# ***Caltex Kurnell Refinery Conversion***

*State Significant  
Development  
Modification Assessment  
(SSD 5544 MOD 5)*

May 2019

**Figure 3** | Location of the ACS containment cell and the section of CWO pipeline proposed to be retained

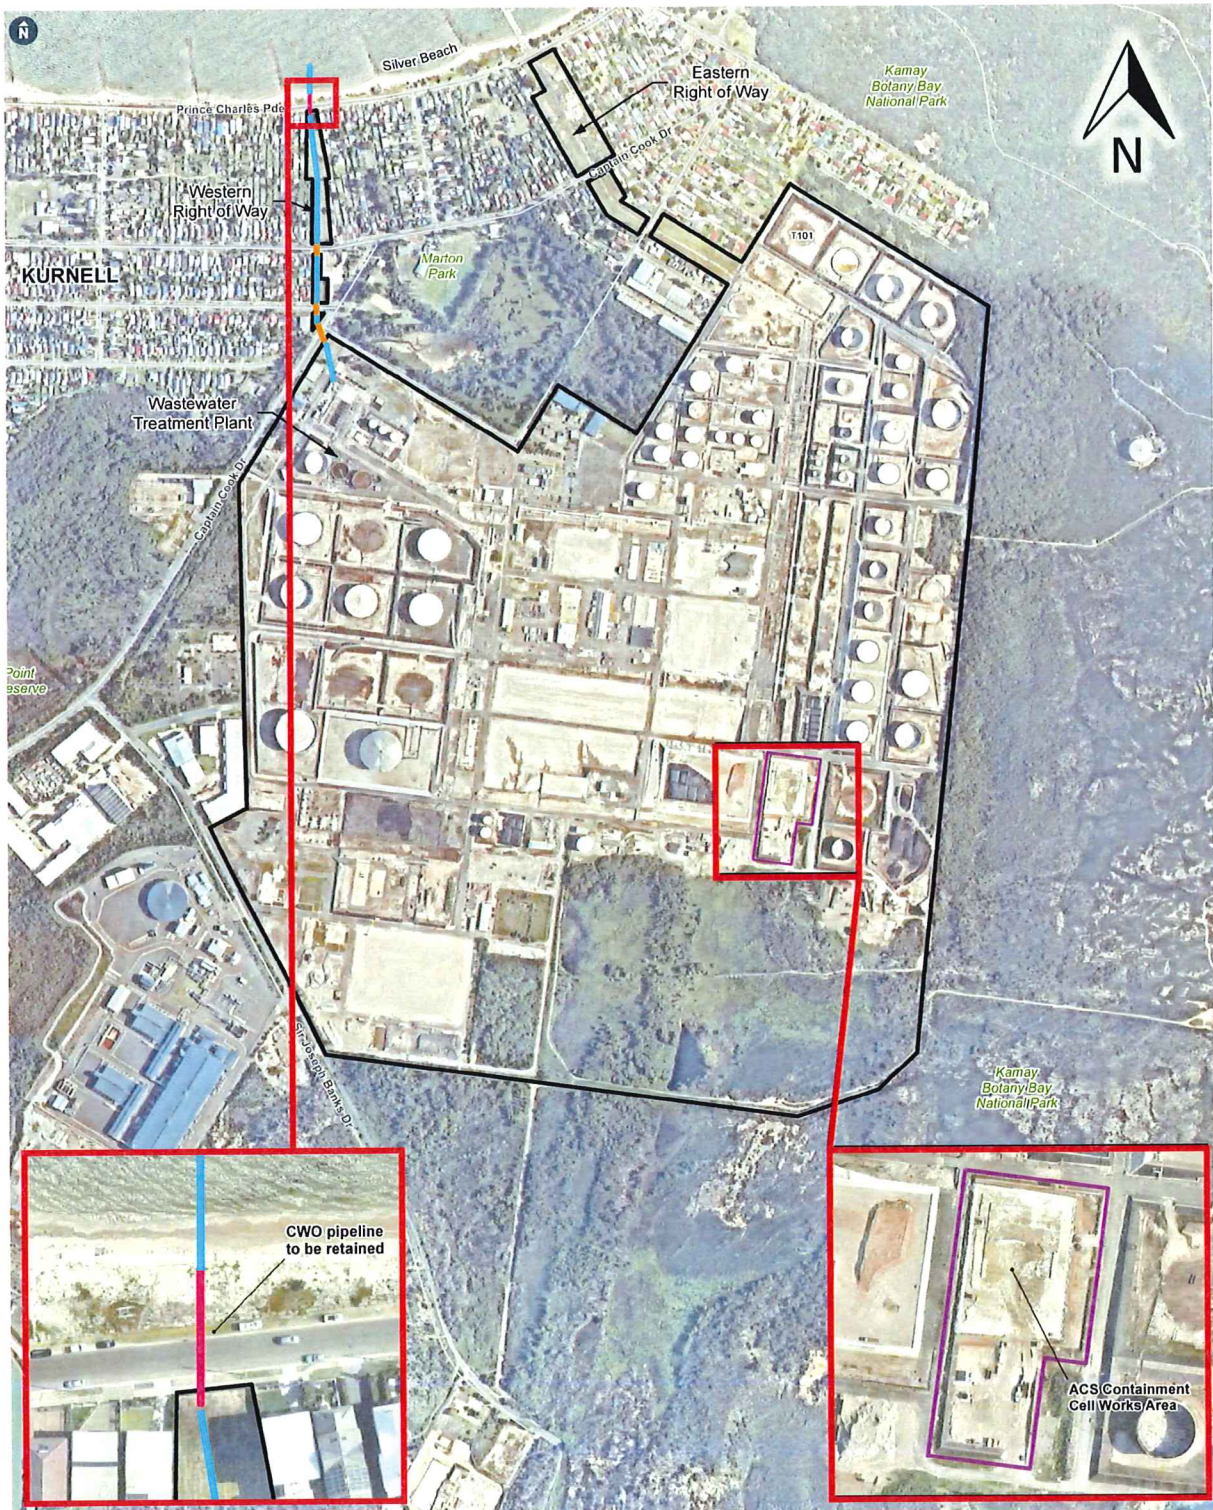
- In addition, the ACS containment cell is located in the south-eastern corner of the site and is shielded from nearby sensitive receivers by existing tanks and infrastructure (see **Figure 3**).

- Since the determination of SSD 5544 MOD 1, the Applicant has come to an agreement with Council to retain a 35 m section of the CWO pipeline beneath the Prince Charles Parade road corridor and the Silver Beach dune area. The Applicant is subsequently seeking the retention of this section of the pipeline as part of the current modification.

- The retention of this section of the pipeline has the potential to impact coastal processes within the dune area and the future installation of services within the road corridor.

- The Applicant's assessment of the proposed modification concluded the CWO pipeline is:
    - located approximately 4 m below the surface of the Silver Beach sand dune, and consequently is unlikely to impact upon coastal processes in this area

- located approximately 3.2 m below the existing ground level in the Prince Charles Parade road corridor, and consequently is unlikely to impact upon the future installation of services in this area.

- Condition B7B is to be amended to reference '30 November 2019', instead of '30 April 2019'.

- Conditions B16A and C32C are to be removed.
  - Condition C43C is to be updated to remove references to marine ecology impacts and works beneath the Silver Beach dune area.
